**Commercial Lease of Submerged Lands for Renewable Energy
Development on the Outer Continental Shelf, OCS-A 0498 –
40 CFR Part 55 OCS Air Permit Application**

OUTER CONTINENTAL SHELF AIR PERMIT APPLICATION

Ocean Wind, LLC Energy Project FLiDAR Buoy Deployment

Subject Met-buoy Air Permit Application
To Viorica Petriman
Copy Sara Ayres, Melanie King, Suilin Chan, Sara Froikin, Dan Ryan, Peter Fontaine, Julian Ralf Jensen, Elizabeth-Anne Treseder, Laura Sliker
From Marcus Cross
Regarding Response to questions from the EPA Region 2 on Ocean Wind Air Permit application for the deployment of met-buoys

2TNV70-HGE

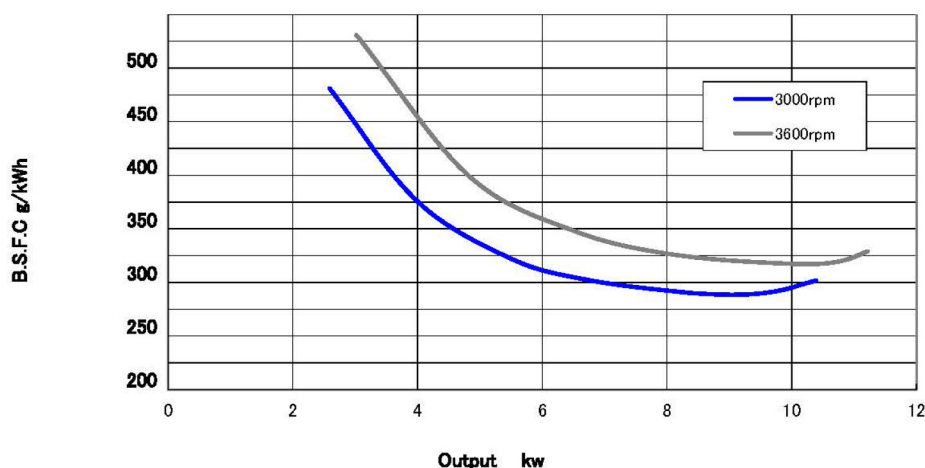
*In the Ocean Wind application the met buoys diesel-fueled engines are described as Yanmar 2TNV70 engines, rated at **10 kilowatts (13.4 horsepower)**, and indicates that the engines will be derated to 3.5 kW (4.5 BHP). However, in the engine's information from Yanmar, which are included in Appendix B of the application (see attached), the engines are described as 2TNV70 Yanmar engines, rated at **13.4 kilowatts (10 horsepower)**. Would it be possible to clarify this inconsistency?*

The Yanmar data sheet has the kW and hp labels reversed. The correct (original) rating should be 10 kW, equal to 13.4 hp and this is what was used in our emission calculations
